**RALEIGH COUNTY AIRPORT AUTHORITY
RALEIGH COUNTY, WEST VIRGINIA**

TAXIWAY F

ADDENDUM #2

THRASHER PROJECT #080-10038

SHEET No.	7
-----------	----------

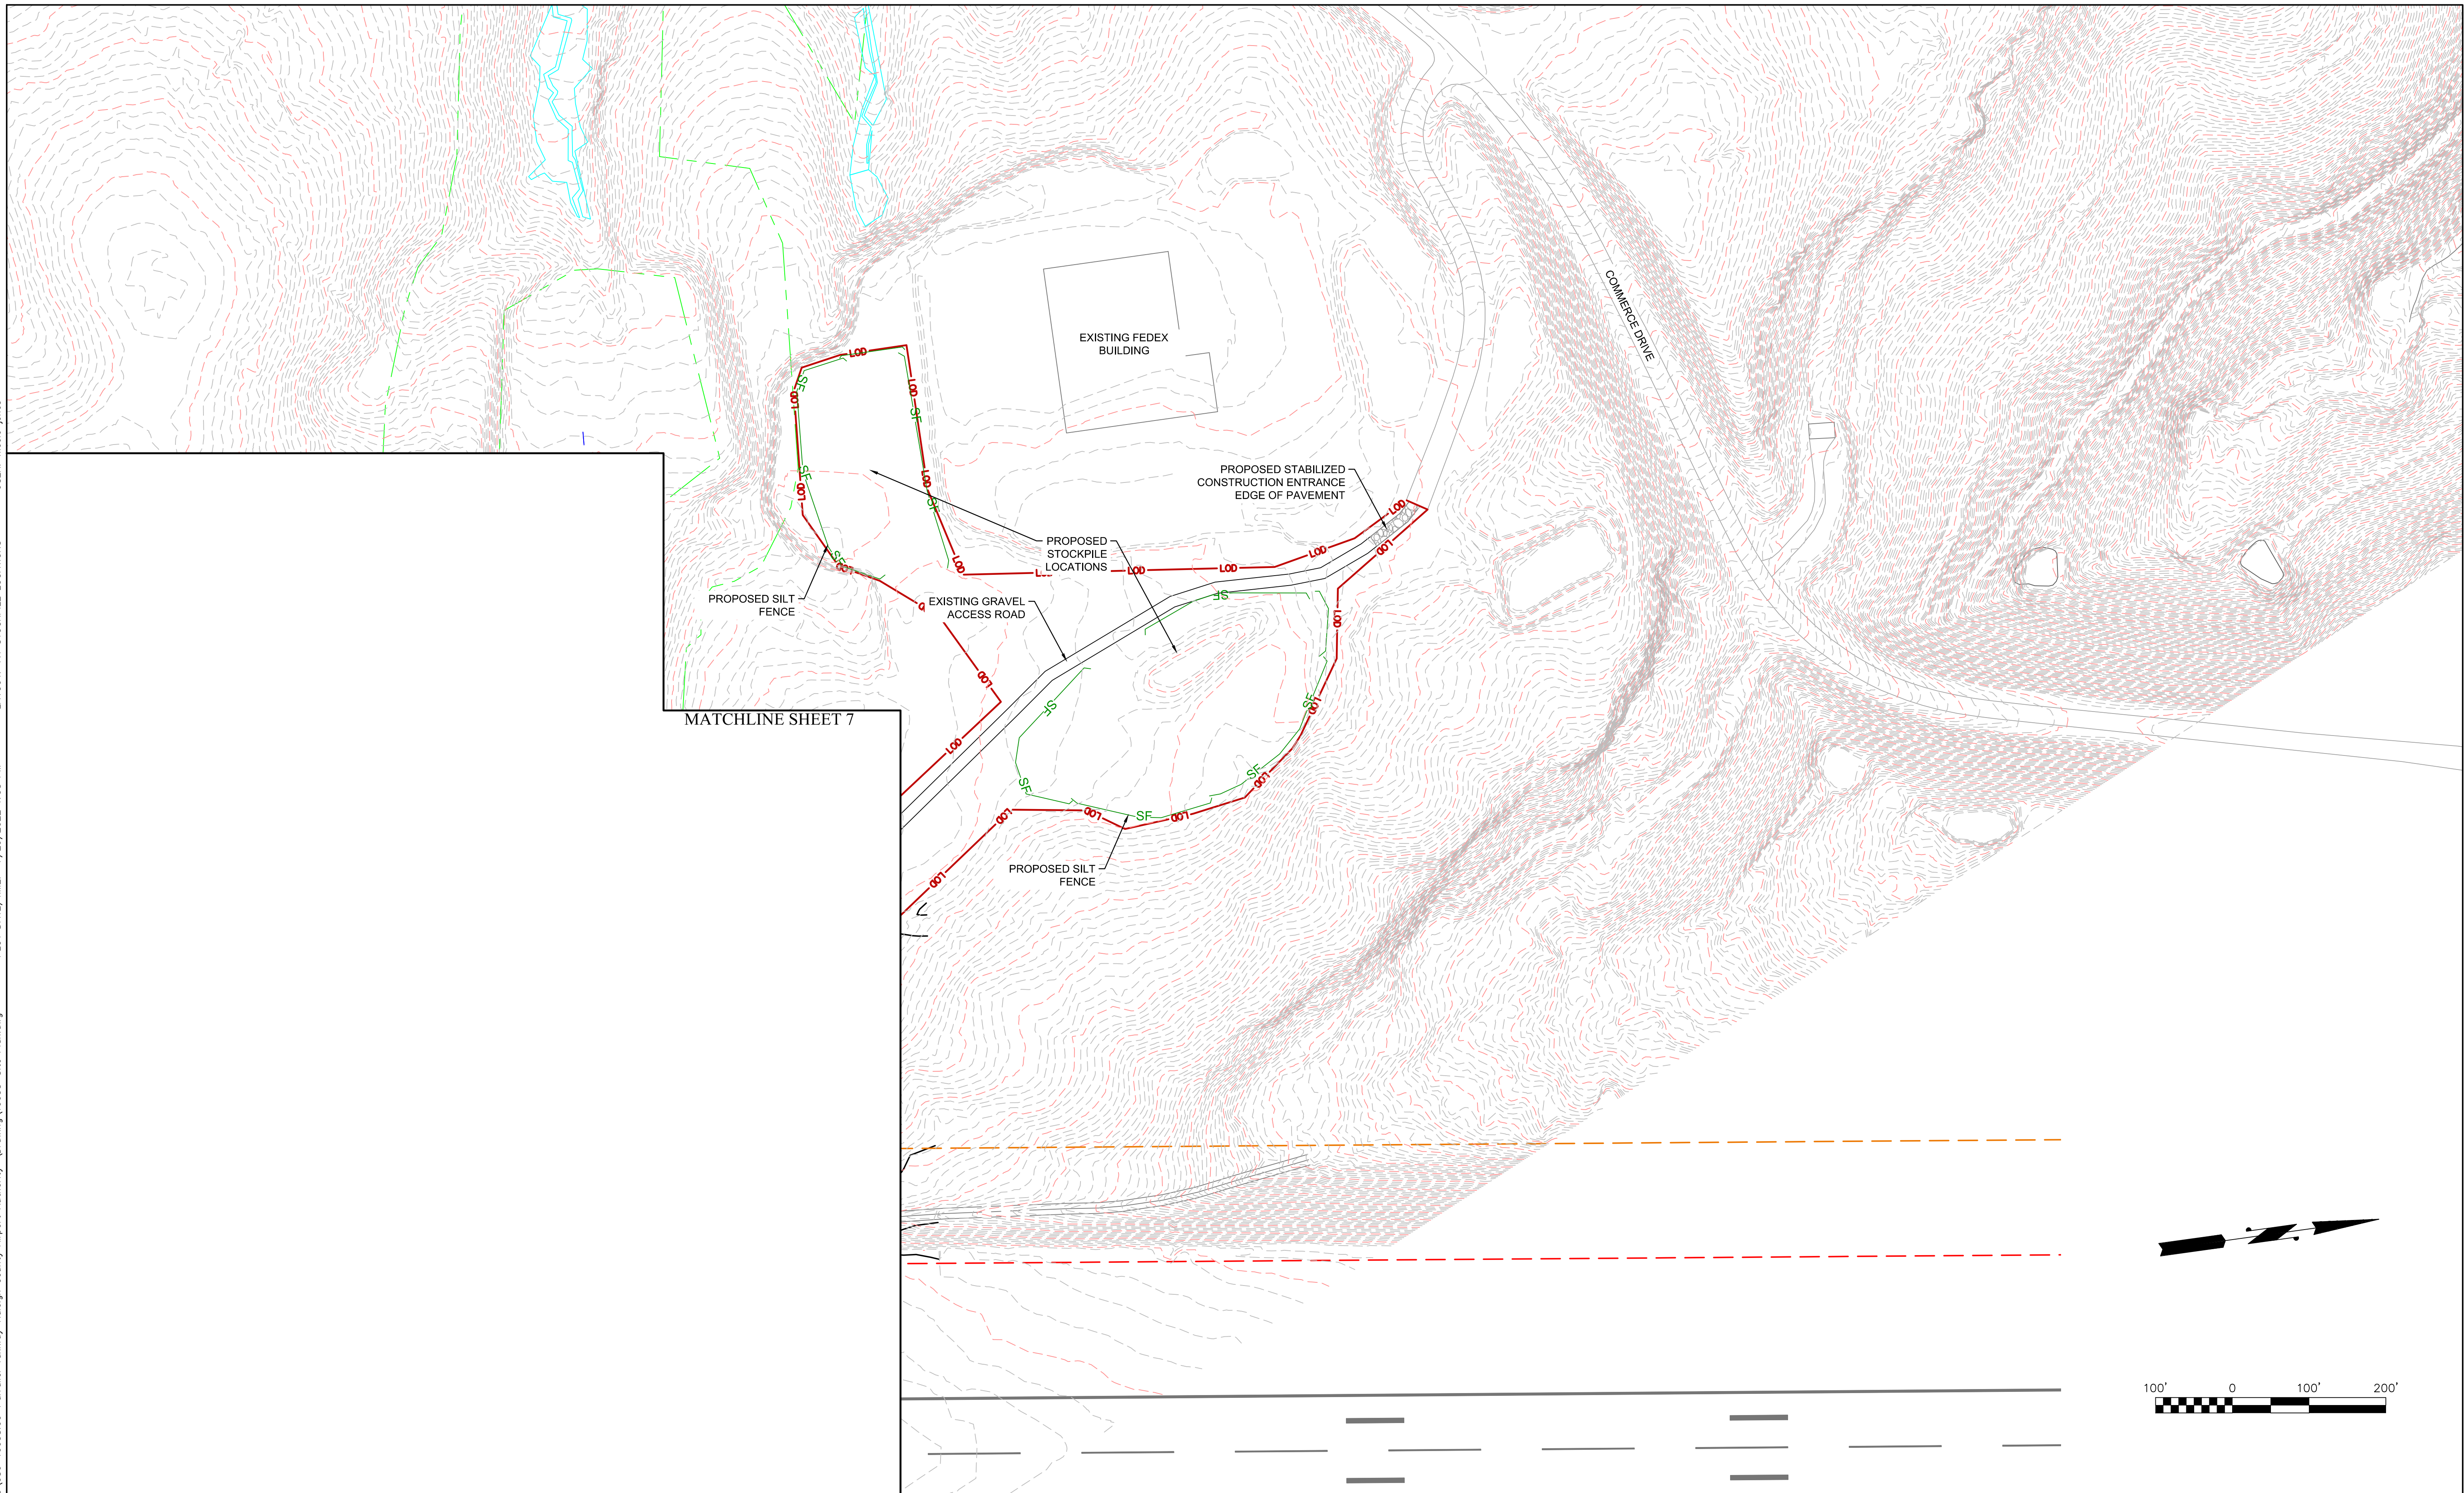
48. Would the re-striping of the enhanced box markings for hold position and existing centerlines per the note on Sheet 7 require the black border?

Yes, a black outline is required for all new/replaced pavement marking on existing pavement for the construction of Taxiway F.

SHEET No.
7.1

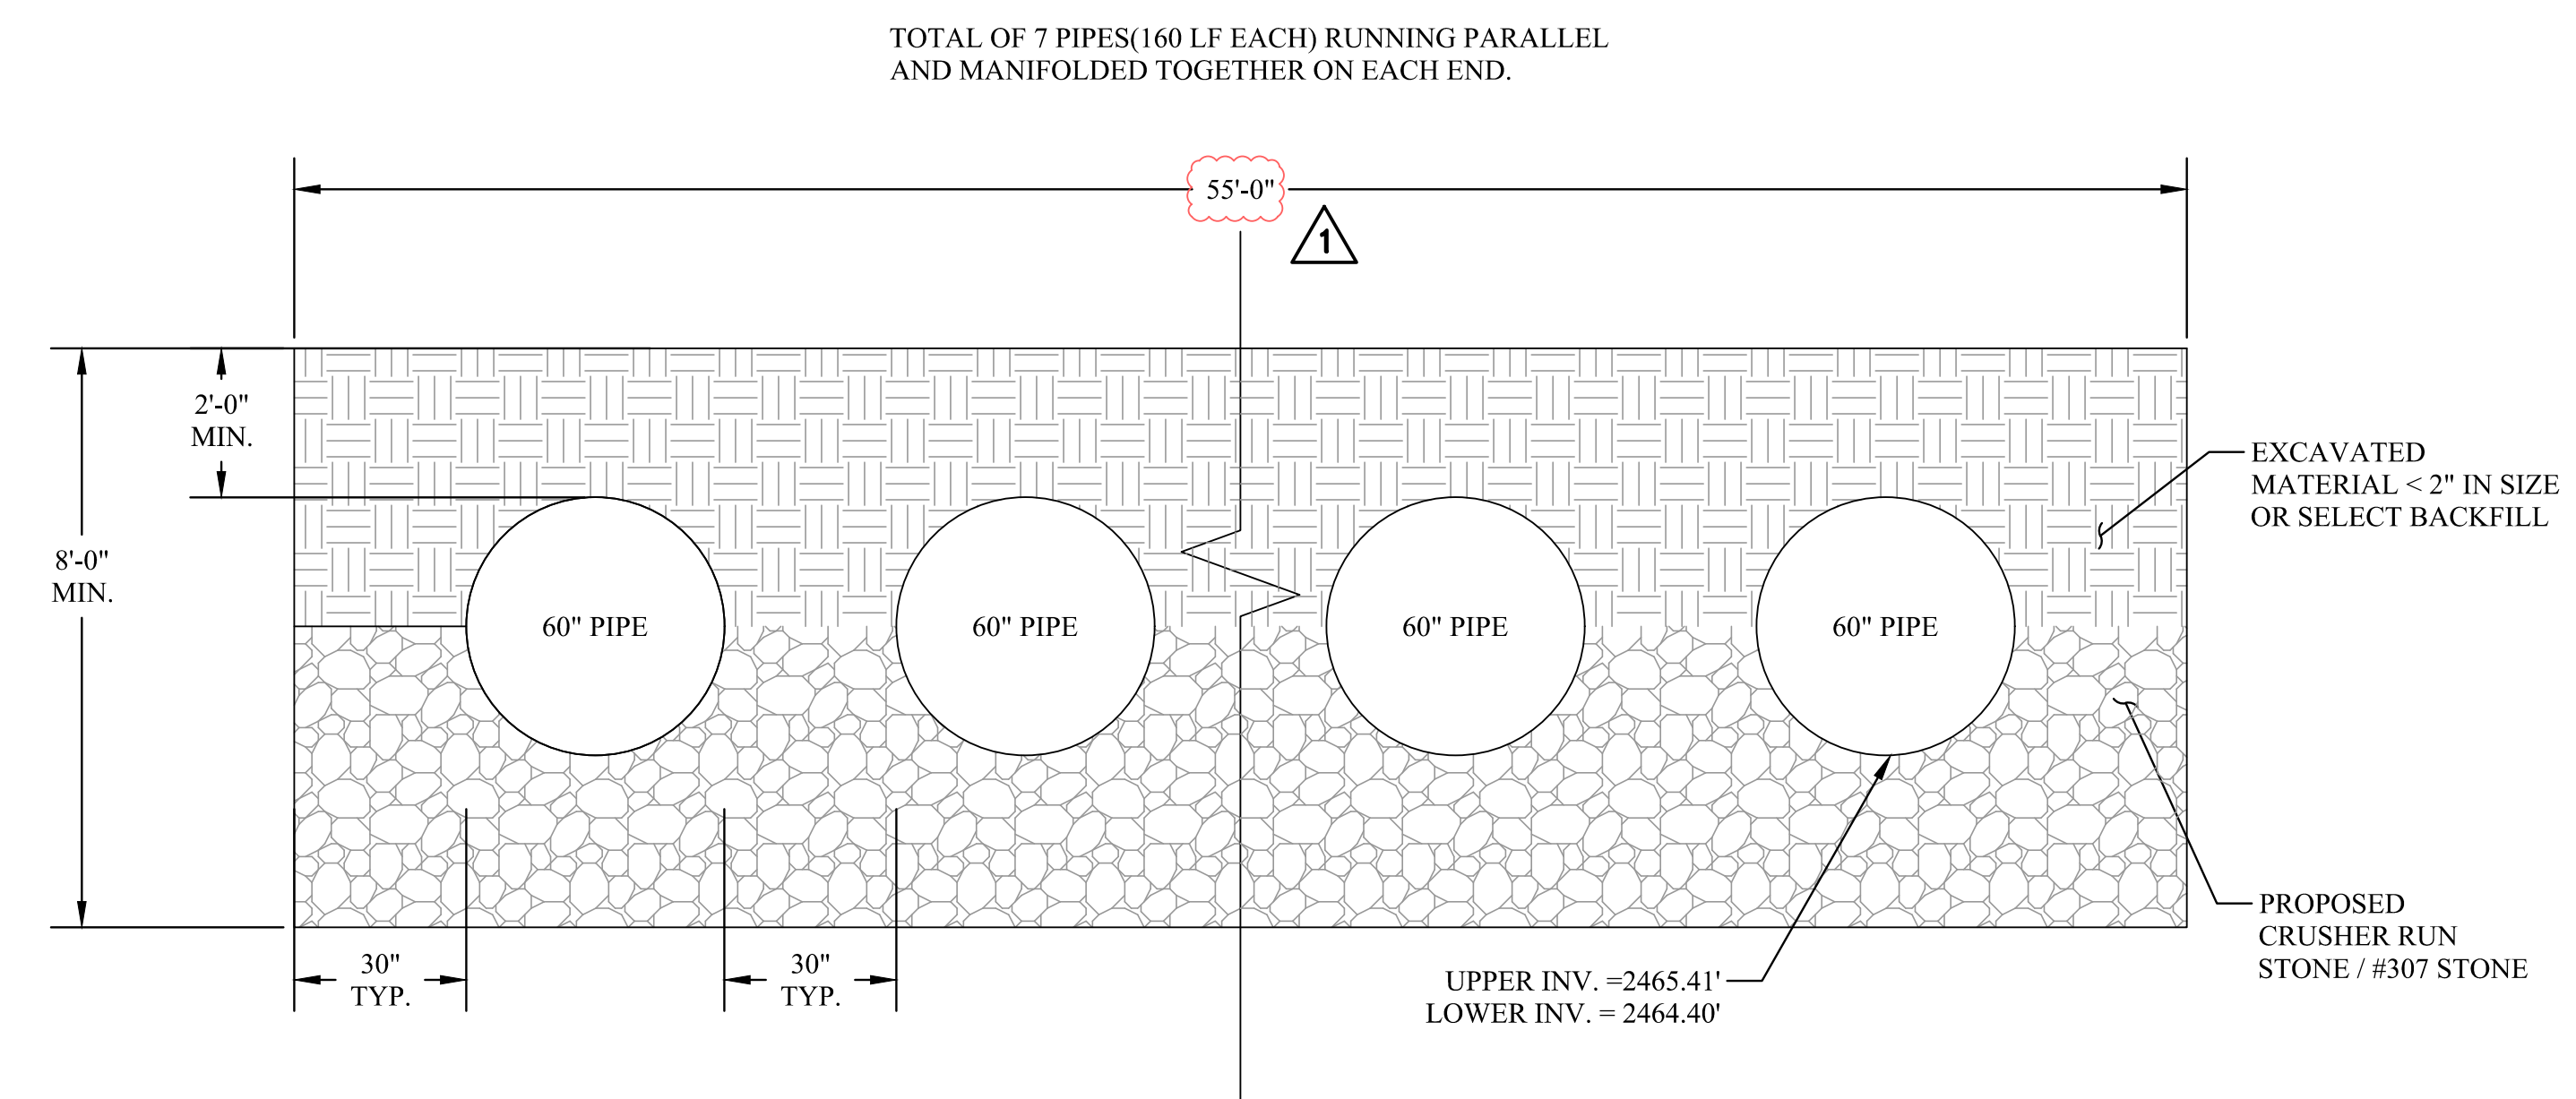
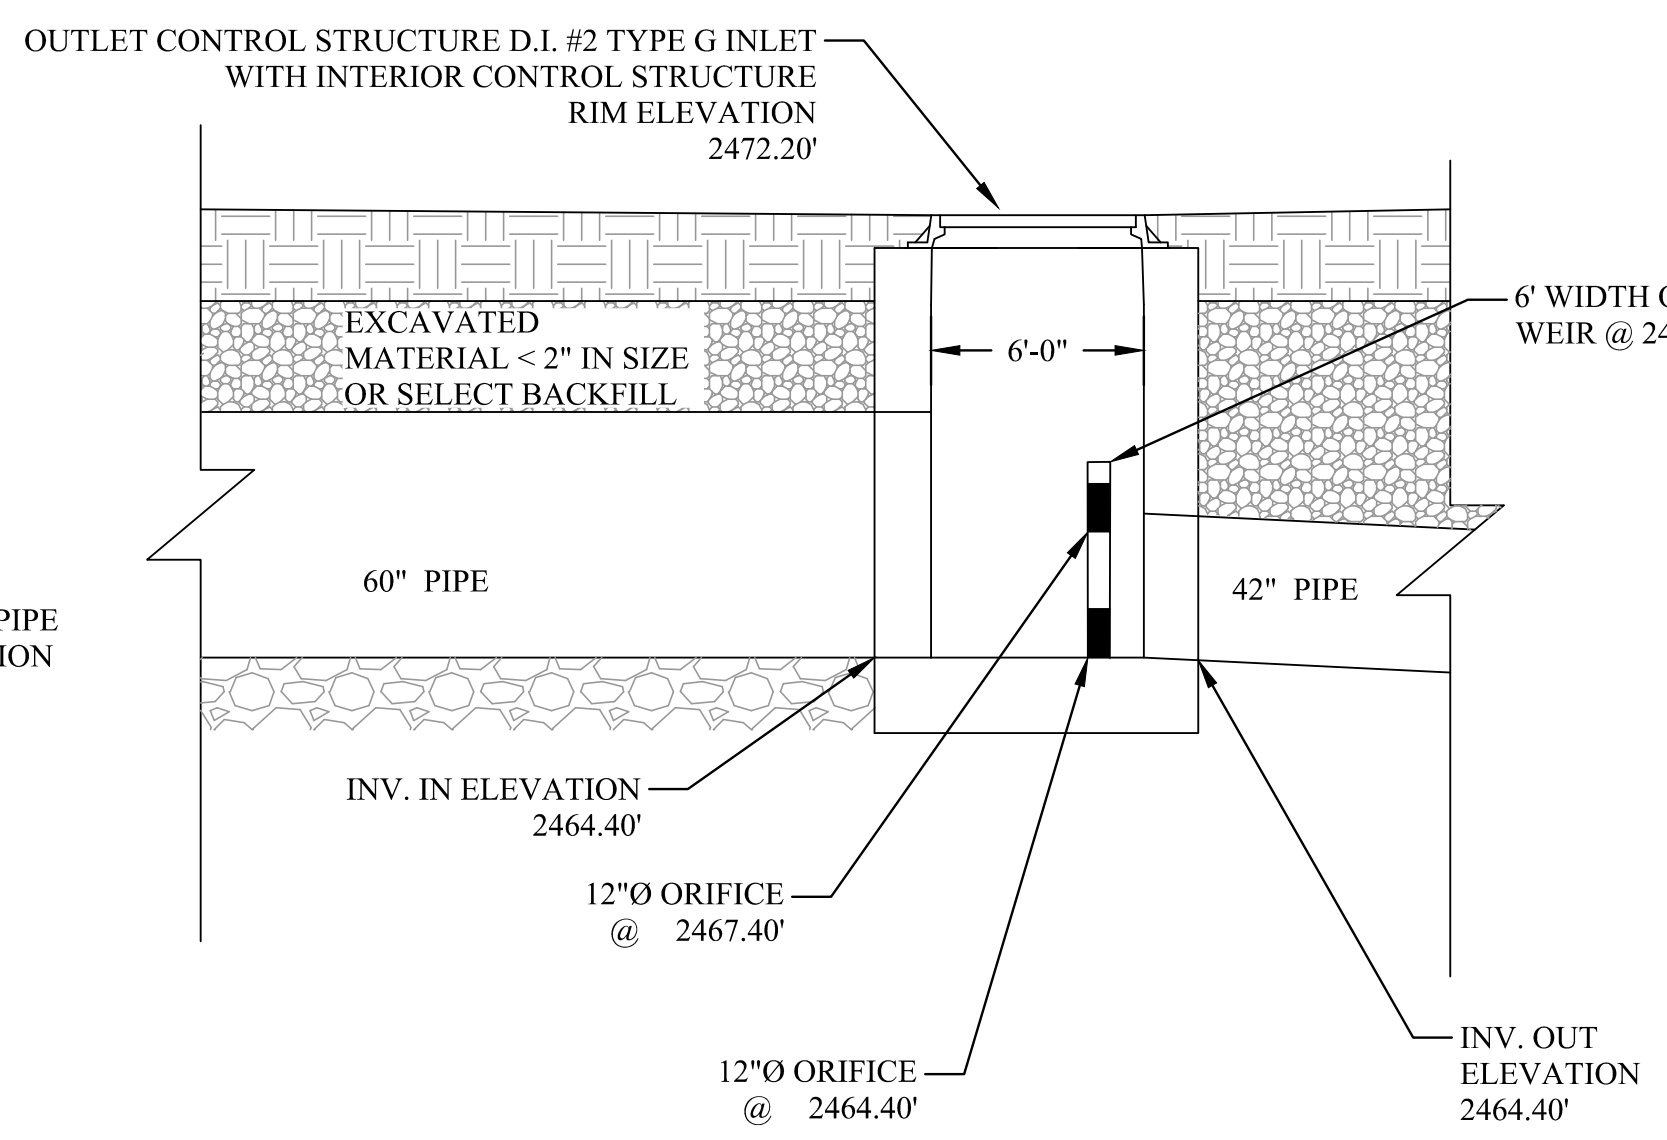
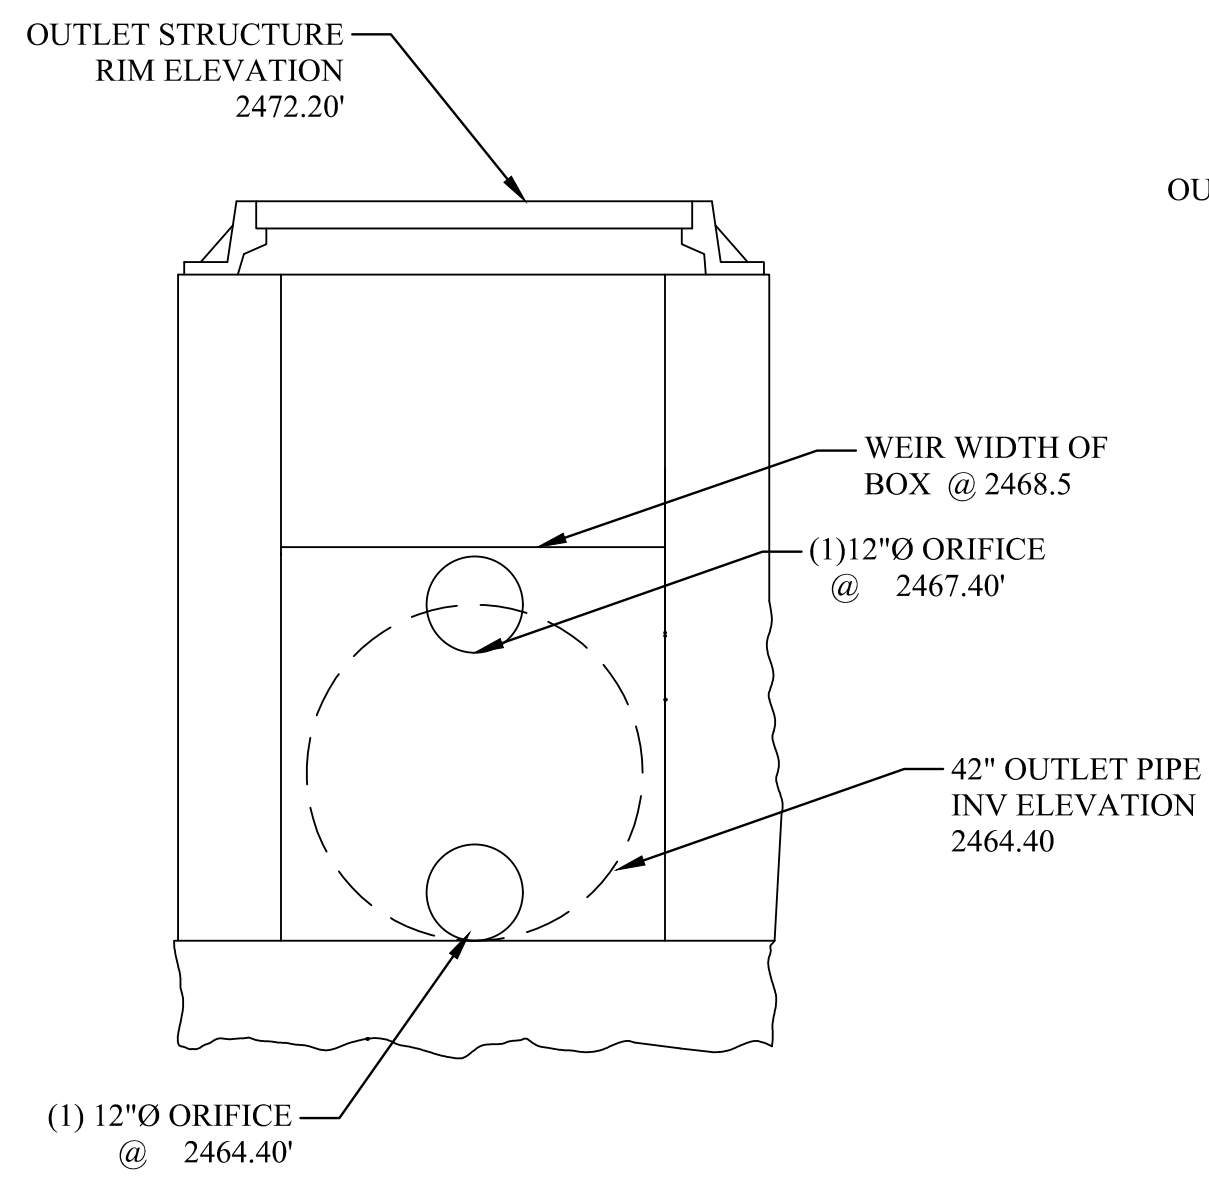
2. Where will the location of the excess material stockpile be located? Are there any excess material requirements since it will be used for fill on the industrial park project by others.

18. Will clearing and erosion control have to be done on the site project by the Taxiway contractor before stockpiling can begin?

23. Will undercut materials also be taken to the future site project?

Sheet 7.1 has been added to show the location of the stockpile areas for the project. There are no material requirements for the identified stockpile areas except for being clean of any trash, stumps, etc.

Clearing and Erosion control will have to be performed prior to placing stockpiled material. Sheet 7.1 has been added to show the location of the stockpiles.

If material is identified as unsuitable it can be hauled to the stockpile locations identified on Plan Sheet 7.1.

The unsuitable quantity is in addition to the unclassified. Unsuitable material can be hauled to the stockpile locations identified on Plan Sheet 7.1.
